# CLIO II

## 19 CLANKING NOISES UNDER THE BODY

Basic manual:  
Repair manual 337

Fig. 1

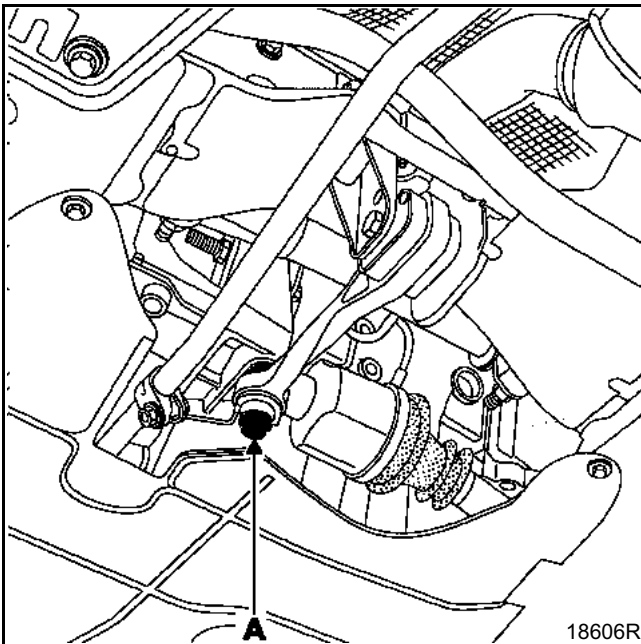
- Clanking sound under body when engine started or stopped or under torque reaction.
- Gear change difficult.

- Insufficient tightening of torque reaction arm bolt (A in Fig. 1) on gearbox side.

Fig. 2

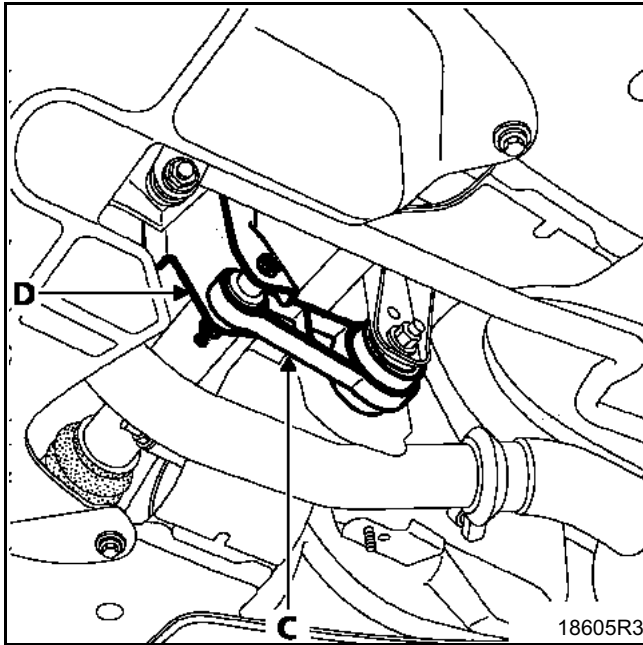
- Fit a torque reaction arm (C in Fig. 2).

Remove the original torque reaction arm.

– The mounting (D in Fig. 2) **Part Number.: 77 00 419 509**

– The torque reaction arm (C in Fig. 2)

**Part Number.: 77 00 415 095**

- using the bolts **Part Number.: 77 03 101 175**
- and the nuts **Part Number.: 77 03 034 151**

Fig. 3

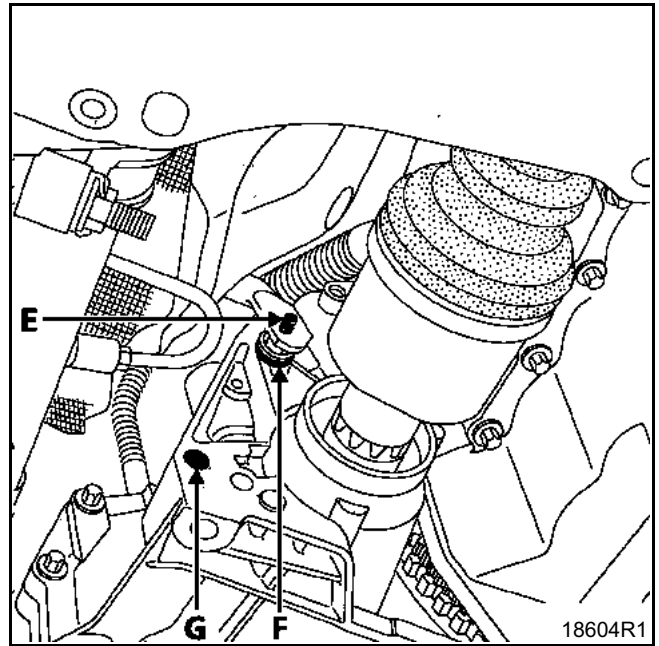
- The original torque reaction arm
- The catalytic converter flange mounting bolt (E in Fig. 3).

Replace the original 5 mm (F in Fig.3) with a 2 mm washer **Part number.: 77 03 053 075.**

– The mounting (D in Fig. 2) **Part number.: 77 00 419 509** by attaching it at the lower end (G in Fig. 3)

**Part number.: 77 03 101 175** and at the upper end to the catalytic converter flange mounting bolt (E in Fig. 3).

– The torque reaction arm (C in Fig. 2) **Part Number.: 77 00 415 095**

- using the bolts **Part Number.: 77 03 101 175**
- and nuts **Part Number.: 77 03 034 151**

Tighten the bolts to the correct torque.
